**Vogle Electric Generating Plant Units 1 and 2
License Amendment Request to Revise Technical Specification (TS)
Sections 5.5.9, "Steam Generator (SG) Program" and TS 5.6.10,
"Steam Generator Tube Inspection Report" for Interim Alternate Repair Criterion**

**Westinghouse Electric Company LLC, LTR-CDME-08-043 NP-Attachment, "Response to
NRC Request for Additional Information Relating to LTR-CDME-08-11 NP-Attachment,"
dated March 18, 2008**

**Response to NRC Request for Additional Information Relating to
LTR-CDME-08-11 NP-Attachment**

**QUESTIONS RELATING TO STEAM GENERATOR TUBESHEET
AMENDMENT ON INTERIM ALTERNATE REPAIR CRITERIA**

Figure 11-3: Tube Crack Geometry

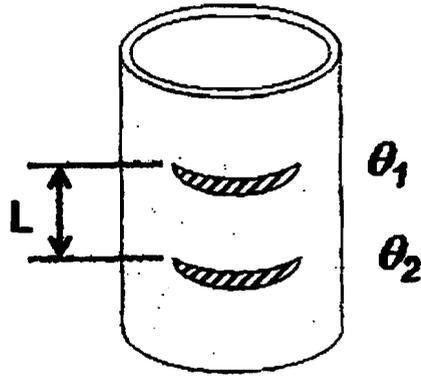
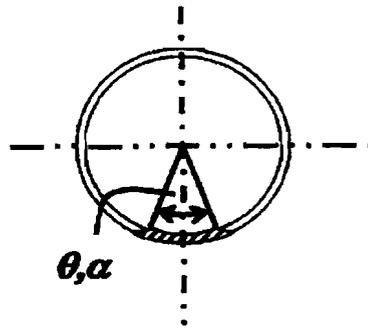
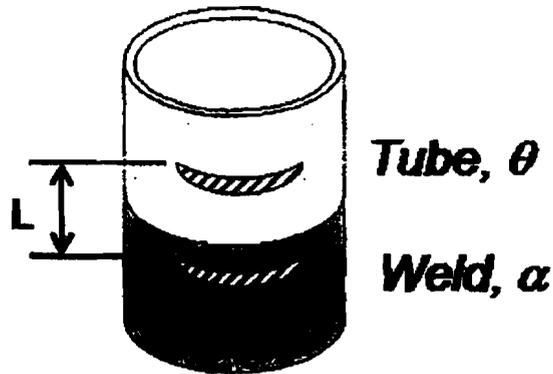
11. The proposed tube and weld repair criteria do not address interaction effects of multiple circumferential flaws which may be in close proximity (e.g., axial separation of one or two tube diameters). Address this concern and identify any revisions which may be needed to the alternate tube repair criteria and the maximum acceptable weld flaw size.

The impact of the crack separation analysis is summarized below. Refer to Figures 11-3 through 11-5 for explanations of the crack geometries and combinations of crack-like indications considered in the analysis. Table 11-1 is a summary of the text description of the crack separation analysis impacts. The details described in Table 11-1 apply only to the portion of the tube within the tubesheet 17 inches below the top of the tubesheet (TTS-17 inches).

1. If any circumferential crack-like indication in the tube exceeds 203°, plug the tube.
2. If there is more than one circumferential crack-like indication in a tube, and no single crack angle exceeds 203°, and the minimum axial distance of separation between the crack-like indications is

greater than or equal to 1.00 inch, then the maximum crack angle is used to describe the flaw and the tube remains in service.

3. If there is more than one circumferential crack-like indication in a tube, and no single crack angle exceeds 203° , and the minimum axial distance of separation between the crack-like indications is less than 1.00 inch, and the non-overlapping sum of the crack angles plus the overlapped crack angle is less than or equal to 203° , the tube may remain in service.
4. If there is more than one circumferential crack-like indication in a tube, and no single crack angle exceeds 203° , and the minimum axial distance of separation between the crack-like indications is less than 1.00 inch, and the non-overlapping sum of the crack angles plus the overlapped crack angle is greater than 203° , plug the tube.

5. If there are one or more cracks in the tube that are each less than or equal to 94° , and there is a minimum axial separation distance between the tube end and the tube cracks of less than 1.00 inch, and the non-overlapping sum of the tube crack angles plus the overlapped crack angle is less than or equal to 94° , the tube may remain in service.
6. If there is a crack-like indication in the weld less than or equal to 94° and there are one or more cracks in the tube that are each less than or equal to 94° , and there is a minimum axial separation distance between the tube end and the tube cracks of less than 1.00 inch, and the non-overlapping sum of the tube crack angles plus the overlapped crack angle is greater than 94° , plug the tube.

1. See Figures 11-3, 11-4 and 11-5 for tube crack angle and weld crack angle definition.
2. θ_n is the sum of any remaining crack angles after the first two crack-like indications. For example, the statement: $\theta_1 + \theta_2 + \theta_n \leq 203^\circ$ is equivalent to writing: $\theta_1 + \theta_2 + \theta_3 + \dots \leq 203^\circ$.
3. Separation distance, L, is measured from the tube end.
